Enclosure 3
NRC Handouts
of the May 2, 2012
ROP Public Meeting

Whitepaper for Drill and Exercise Performance Indicator Criteria Revision

**NRC Comments on
FAQ 12-01 (~~Proposed~~) re. Columbia DG3 Failure
For May 2, 2012 ROP WG Meeting**

Plant: Columbia Generating Station (CGS)

Figure 1, Load and current profile during DG3 Operation on 2/28/10

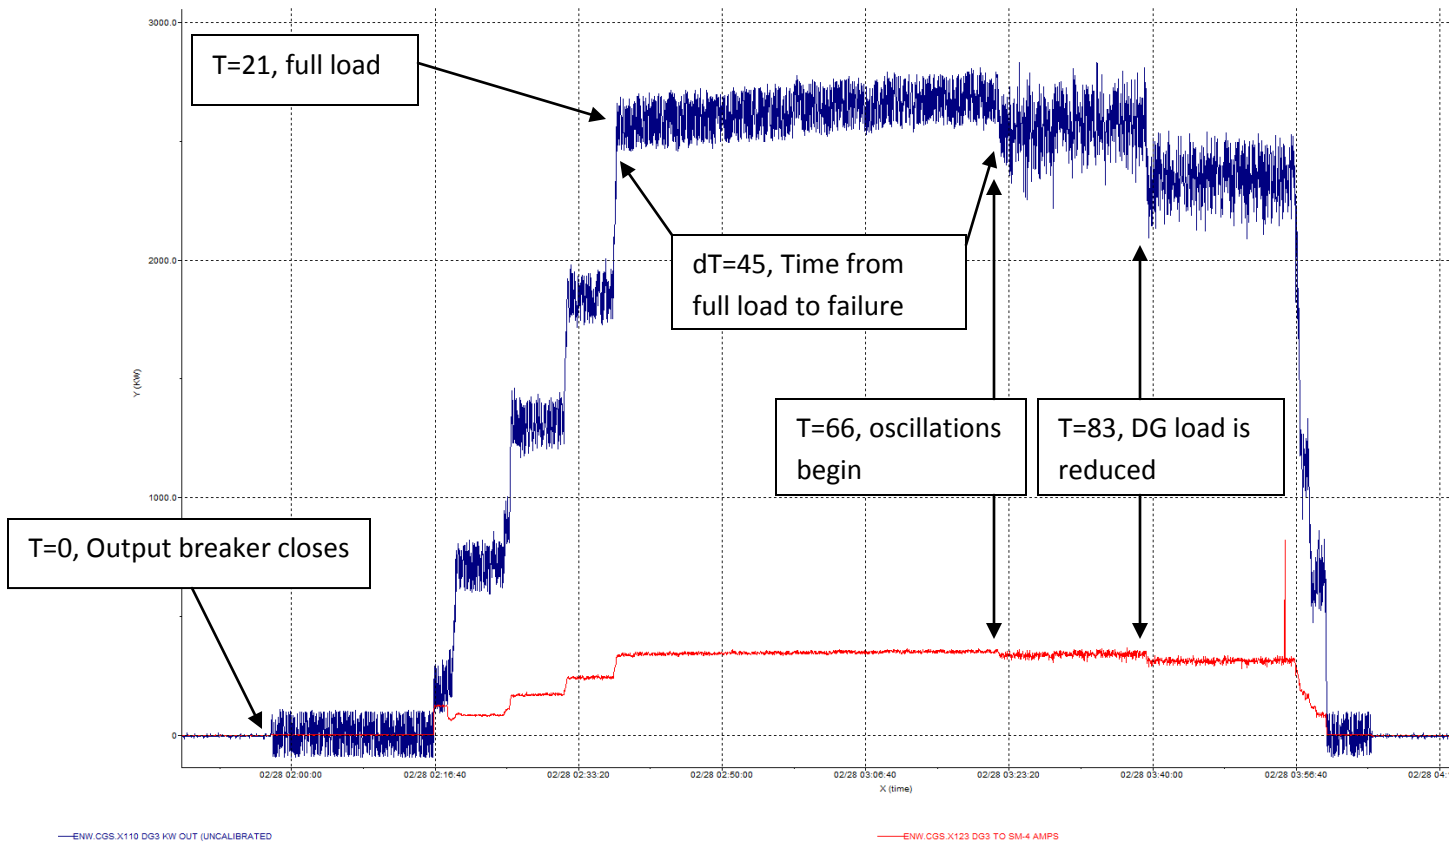
On February 28, 2010, CGS was testing an Emergency Diesel Generator (EDG). Refer to figure 1 for Load and Current trace of the subject event. The EDG successfully started, the EDG output breaker successfully closed (T = 0 minutes), the EDG successfully load sequenced up to fully loaded (T = 21 minutes), after 45 minutes the EDG experienced unexpected load oscillations of 350 kw (T = 66 minutes), after 17 minutes the load was lowered (T = 83 minutes) and the 350 kw oscillations were observed to continue another 16 minutes of operation until the EDG was unloaded (T = 99 minutes) and shut down.

CGS and the CGS NRC Senior Resident Inspector (SRI) do not agree that CGS properly reported the February 28, 2010 EDG failure. NEI 99-02 defines “EDG failure to load/run”. In part, it states: “Given that it has successfully started, a failure of the EDG output breaker to close, to successfully load sequence and to run/operate for **one hour** to perform its monitored functions.” The intent of this FAQ is to clarify that based on the guidance available at the time the start time for the “one hour” period begins once the EDG has completed its load sequence and is loaded (at T=21 and not at T=0 (as per figure 1)). Based on the response to FAQ Number 487, CGS understands that as of 1/1/2012 the “one hour” period begins at output breaker closure (T=0 per figure 1).

Regardless of the time the 1 hour clock started, the resident inspectors believe that this failure should be considered as an “EDG failure to run”. Plant data revealed that at 3:22 AM, DG-3 began to exhibit degraded performance but still provided an average (based on 1 minute average) of >2547 KW which is sufficient to meet all post-accident loads. The diesel engine was allowed to continue to operate until about 3:42 AM when the control room operators logged that after running DG-3 fully loaded for **over an**

hour (emphasis added), the component exhibited load swings of 200-300 KW. The component was secured due to the degraded performance shortly after the operators logged the issue with DG-3. Since the component continued to operate after observing the degraded performance, it is not clear if the monitored function was immediately lost or if the component would have continued to operate for its required mission time. To date, the licensee has not performed an engineering evaluation of the degraded condition to determine at what point the monitored function was lost. The inspectors believe that a strong case can be made that a run failure should be assigned based on NEI 99-02, Revision 6, Page F-28, Lines 28-31

The licensee requested that the FAQ resolution clarify that based on the guidance available at the time of the EDG failure, the start time for the “one hour” period begins

once the EDG has completed its load sequence and is loaded (at T=21 and not at T=0 (as per Figure 1)). The licensee's proposed resolution would contradict the FAQ 11-08 resolution and could result licensees reclassifying past EDG failures in a non-conservative manner, which would be unacceptable to the NRC. FAQ 11-08 reflects the intent of the guidance in effect at the time of this failure.

FAQ 11-08, which improved and clarified the EDG failure characterizations, became effective starting with 1Q2012 PI data (after the EDG failure in question at Columbia). Despite the FAQ approval and effective date and the ambiguity of the NEI 99-02 phrasing in effect at the time of the EDG failure, it was the intent of the Revision 6

guidance in effect at the time of the EDG failure in question (i.e., the guidance in effect before approval of FAQ 11-08) to consider this EDG failure as a failure-to-run. The basis for this decision is described as follows.

Because the EDG definitions guidance in NEI 99-02 prior to FAQ 11-08 needed improvement and clarification, the NRC staff evaluated this issue based on the characteristics of the EDG failure (i.e., the functional response of the EDG and the failure mechanism), the intent of the NEI 99-02 guidance at the time of the failure, and applying reasonable decision-making given the guidance in effect at the time of the failure. The oscillations were caused by foreign material in the governor – a condition which had existed for several years and which did not impact prior breaker closure and sequencing operations. Figure 1 in this FAQ shows that the oscillations did not occur during the breaker closure or the load sequencing or gradual loading action. Rather, the oscillations occurred 66 minutes after breaker closure and 45 minutes after the full load (for purposes of the test run) was achieved, which is indicative of a challenge to the EDG’s ability to continue to run for its mission time. Even though the foreign material existed in the governor for several years, the EDG had started and load sequenced several times without failure. Therefore, this failure appears to have been exacerbated by the running of the EDG.

Because Figure 1 data is more reflective of an EDG failure-to-run for its mission time rather than a loading failure and the intent of NEI 99-02 at the time of the failure was clarified via FAQ 11-08, the EDG failure at Columbia should have been reported as a failure-to-run. The staff would have reached the same decision prior to the existence of FAQ 11-08 if the issue had been raised at the time; therefore, this decision does not contradict the footnote on page 3 of NEI 99-02.
